| Safety Recall Campaign     | 2011-2014MY<br>Sorento (XMa) |
| SC284XM (Rev 2, 9/25/2024) | May 2024                     |

### HECU MULTI FUSE REPLACEMENT (SC284XM)

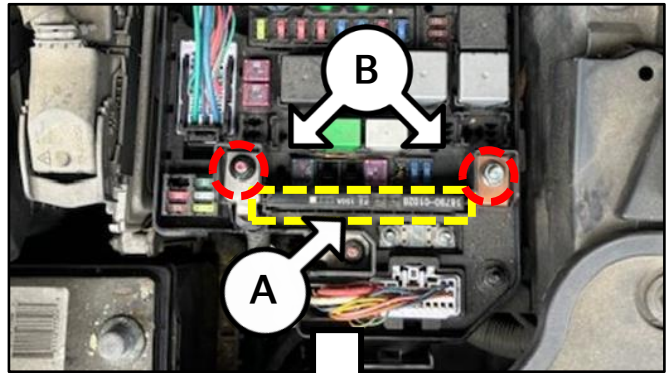
1. Open the hood.
2. Disconnect the negative (-) battery terminal.
3. Remove the junction box fuse cover.

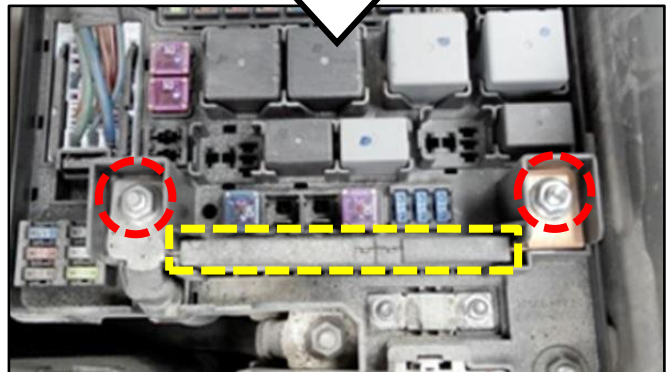
- 4a. Locate the Multi Fuse (A) for ABS1 and ABS2 and loosen the two (2) 10mm Multi Fuse retaining nuts (B) and remove the Multi Fuse.

- 4b. Install the **new** Multi Fuse (A) and tighten the two (2) retaining nuts (B).

Tightening torque for retaining nut (B):  
7.2 - 8.7 lb.ft (9.8 - 11.8 N.m)

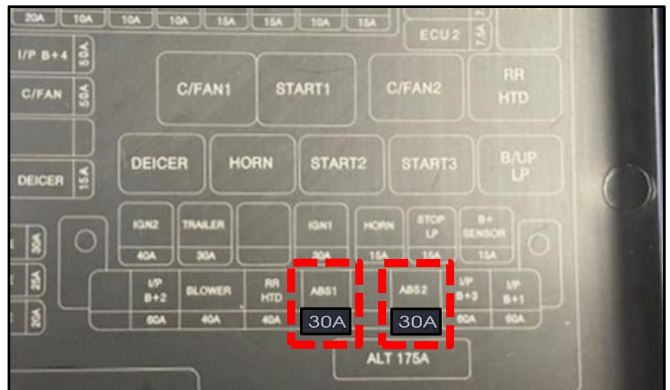
**Note:** Drill a hole through the center of the removed Multi Fuse. DO NOT reuse.

5. Adhere the new ABS1 '30A' and ABS2 '30A' fuse labels to the bottom of the junction box fuse cover, as shown.
